Intel[®] Mobile Celeron[™] Processor at 466 MHz, 433 MHz, 400 MHz, 366 MHz, 333 MHz, 300 MHz, and 266 MHz Specification Update

Release Date July 2000

Order Number: 244444-016

The Intel[®] Mobile Celeron[™] processor at 466 MHz, 433 MHz, 400 MHz, 366 MHz, 333 MHz, 300 MHz, and 266 MHz may contain design defects or errors known as errata which may cause the product to deviate from published specifications. Current characterized errata are documented in this Specification Update.

H29. Thermal Sensor May Assert SMBALERT# Incorrectly

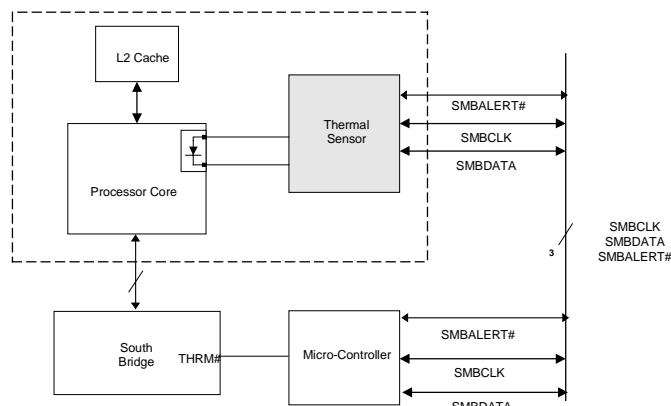
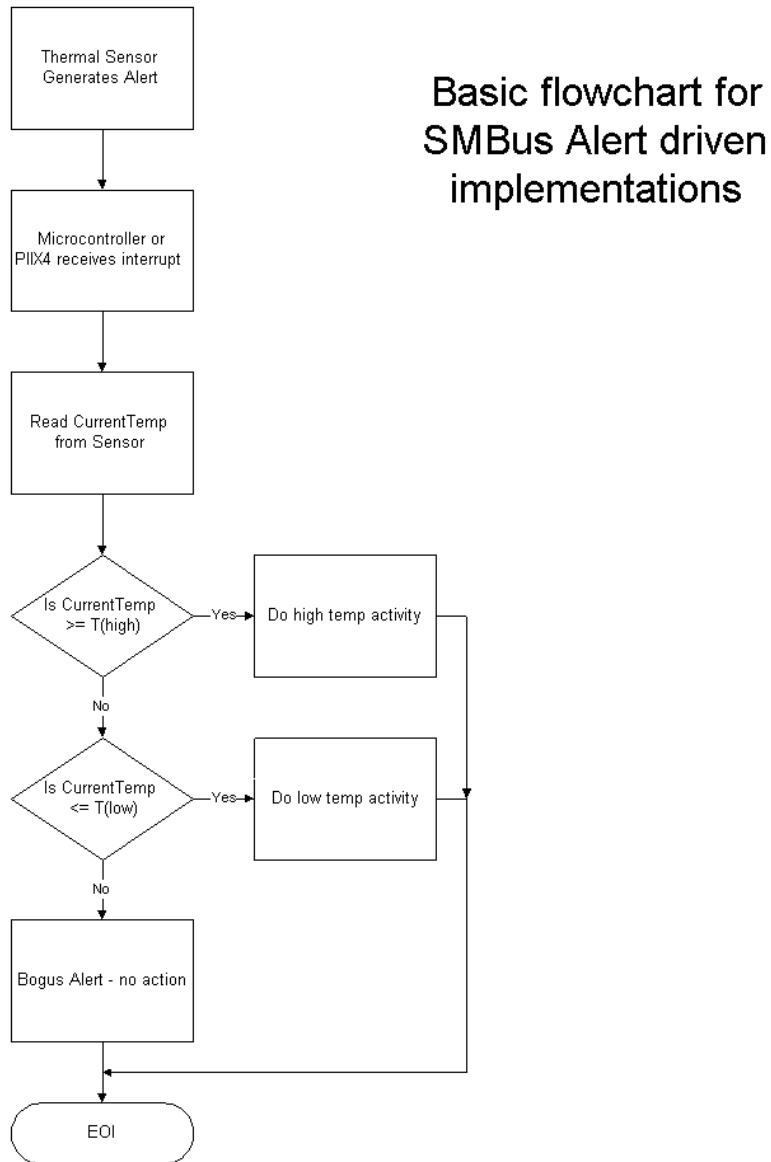
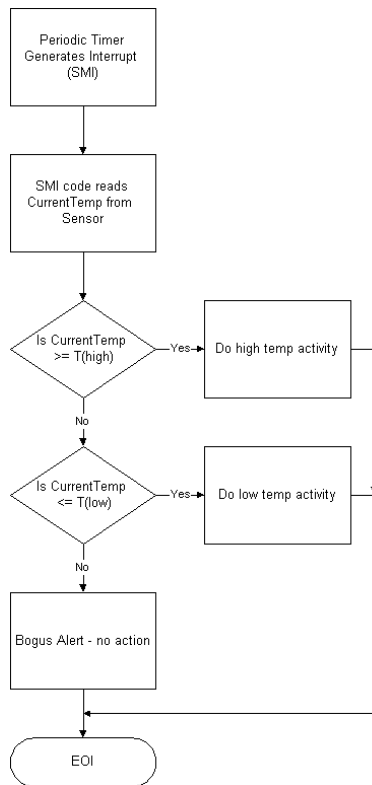
Problem: The Intel Celeron Processor Mobile Module has a thermal sensor that monitors the processor core's temperature. Please note that desktop systems could have a similar thermal device. The thermal sensor asserts SMBALERT# if the processor temperature exceeds the temperature limits set in the Alarm Threshold Registers (T_{HIGH} , T_{LOW}). It also sets the corresponding Status Register bits to identify the cause of the interrupt. Figure 1 gives one example of the how the SMBALERT# signal could be used in a system.

Implication: There is no system impact from this erratum if temperature polling is used for processor thermal management. If the SMBALERT# interrupt is employed to manage processor thermal sensing, then servicing the false interrupt may result in premature system action depending on the software and hardware implementations used. The rate of the false interrupts is less than the auto-convert rate of the thermal sensor.

Workaround: Three different (mutually exclusive) workarounds are possible:

1. Before servicing an interrupt from the thermal sensor, read and compare the processor thermal reading with the threshold limits (T_{HIGH} or T_{LOW}). Figures 2 and 3 provide basic flowcharts for the implementation of this workaround in an interrupt driven system.
2. If the firmware implemented polls the Status Register only, then before taking any action, re-read the temperature register and do a comparison with the alarm threshold limits (T_{HIGH} or T_{LOW}) to determine if the value is actually still within the temperature window.
3. Use a temperature polling scheme to monitor the processor temperature.

Figure 5.3. Surface-Mount BGA1 Package—Top and Side View

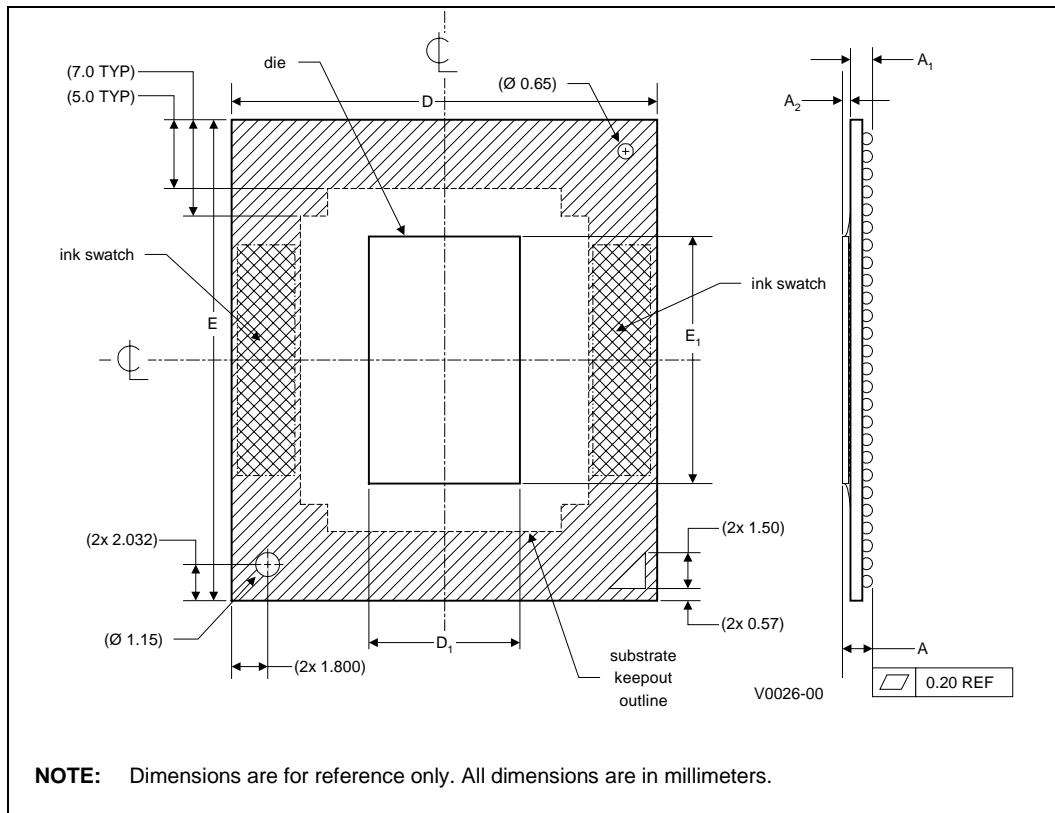
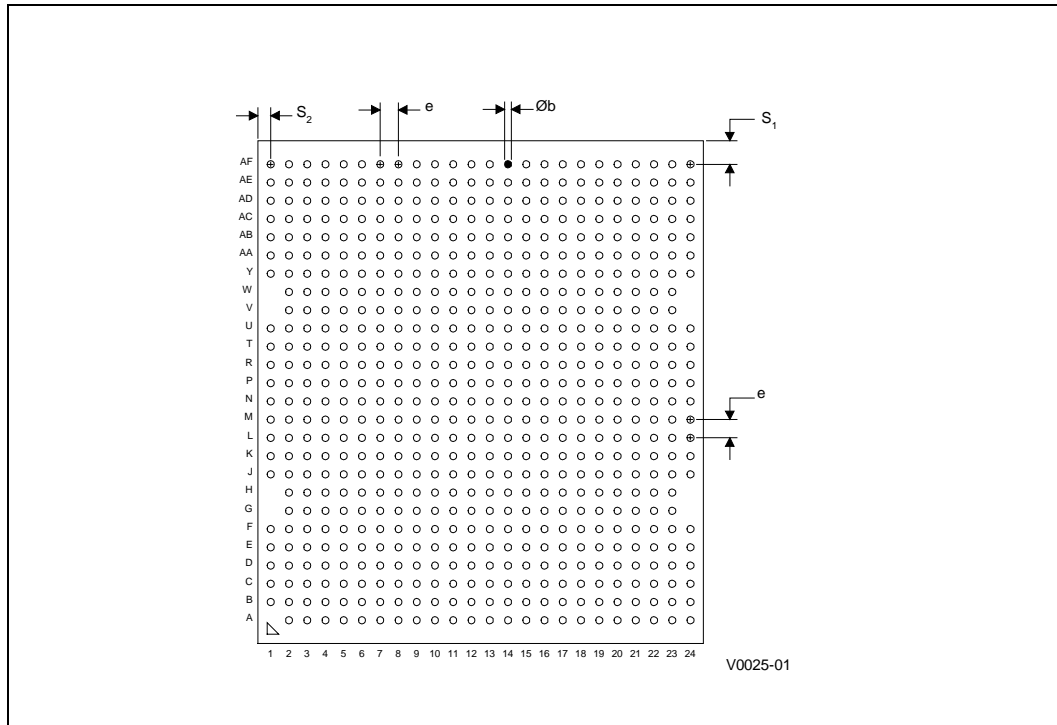
The following table and figures show the updated mechanical specifications for the BGA1 package, listed as Table 5.2, Figure 5.3 and 5.4, respectively, in the *Intel® Mobile Celeron™ Processor in BGA Package at 333 MHz, 300 MHz and 266 MHz* datasheet.

1. The number shown here is different from that in the 244444-004 version of this specification update. The maximum reference number is used.

Figure 3.3 Generic Clock Waveform

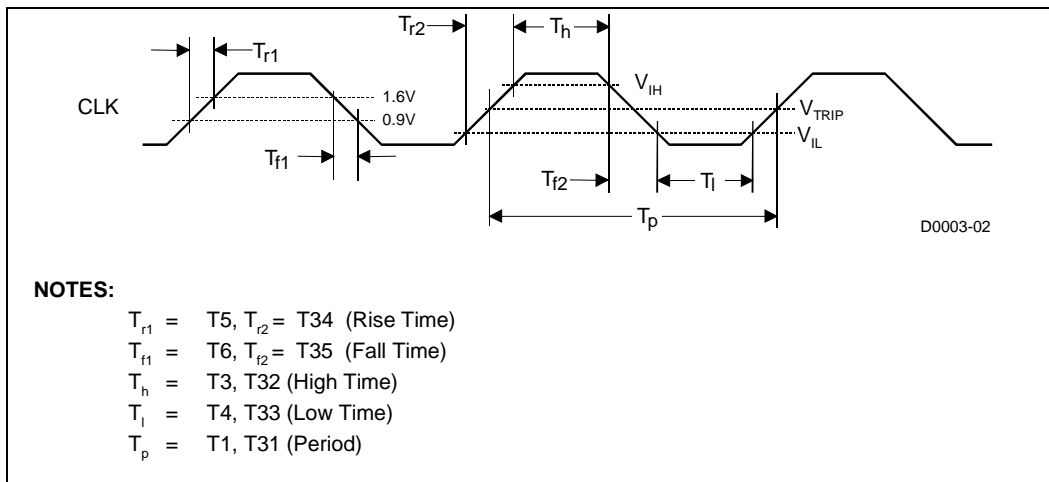
H11. Generic Clock Waveform Figure

Figure 3.3 in the *Intel® Mobile Celeron™ Processor in μPGA1 and BGA1 Packages at 366 MHz, 333 MHz, 300 MHz, and 266 MHz* datasheet (Order Number 245112-003) has been updated. The following figure is to replace the one in the above document.
